UNITED STATES PATENT AND TRADEMARK OFFICE

APPLICATION NO.	FILING DATE	FIRST NAMED INVENTOR	ATTORNEY DOCKET NO.	CONFIRMATION NO.
10/826,046	04/16/2004	Steven S. Homer	200315743-1	9457
22879	7590	08/08/2005	EXAMINER	
HEWLETT PACKARD COMPANY P O BOX 272400, 3404 E. HARMONY ROAD INTELLECTUAL PROPERTY ADMINISTRATION FORT COLLINS, CO 80527-2400			PAPE, ZACHARY	
			ART UNIT	PAPER NUMBER
			2835

Office Action Summary	Application No.	Applicant(s)
	10/826,046	HOMER, STEVEN S.
	Examiner	Art Unit
	Zachary M. Pape	2835

DETAILED ACTION

Fig 1

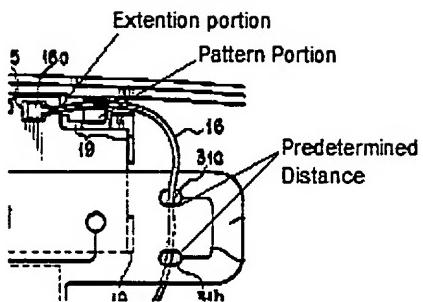
With respect to claim 5, Nakajima et al. further teaches that the antenna comprises a pattern portion (See Fig 1 below)

With respect to claim 6, Nakajima et al. further teaches that the antenna comprises an extension portion extending from the pattern portion to a screen member connector (15, See Fig 1 above).

With respect to claim 18, Nakajima et al. further teaches providing a screen member (10) having a pattern antenna portion (See Fig 1 above) disposed on the interior surface thereof.

With respect to claim 19, Nakajima et al. further teaches providing a screen member (10) having an extension antenna portion (As illustrated in Fig 1 above) extending from the pattern antenna portion (Illustrated in Fig 1 above) to a screen member connector (16a).

With respect to claim 23, Nakajima et al. further teaches that the antenna comprises a pattern portion (See Fig 1 above)

With respect to claim 24, Nakajima et al. further teaches that the antenna comprises an extended portion extending from the pattern portion to a screen member connector (15, See Fig 1 above).

Fig 2

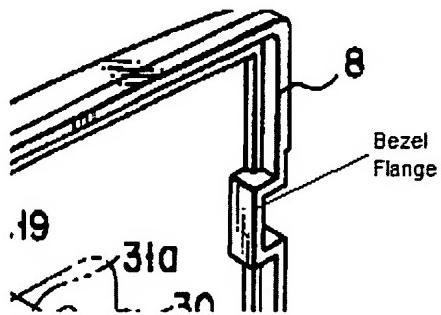
With respect to claim 27, Nakajima et al. further teaches the use of a bezel (8, 9) having a flange (See Fig 2 below) disposed between the screen member and the display device.

With respect to applicant's remarks that the "antenna substrate is clearly not disposed at least partially between the supporting means and an interior surface of the screen member", the examiner directs the applicant to Fig 2 where the illustration shows that the screen member (8) protrudes outward from the means (10). Further the illustration shows that the antenna means (12) is fitted onto the interior surface of the means (10) disposing the antenna in the "gap" or "interval" provided by the protruding screen member from the means (10). The examiner cites the definition of between as set forth in The American Heritage College Dictionary 4th edition, page 136 as: "In or through the position or interval separating". Since the antenna means (12) is disposed in the interval separating the protruding screen member (8) and the means (10) the

antennal means is at least partially between the supporting means and an interior of the screen member.
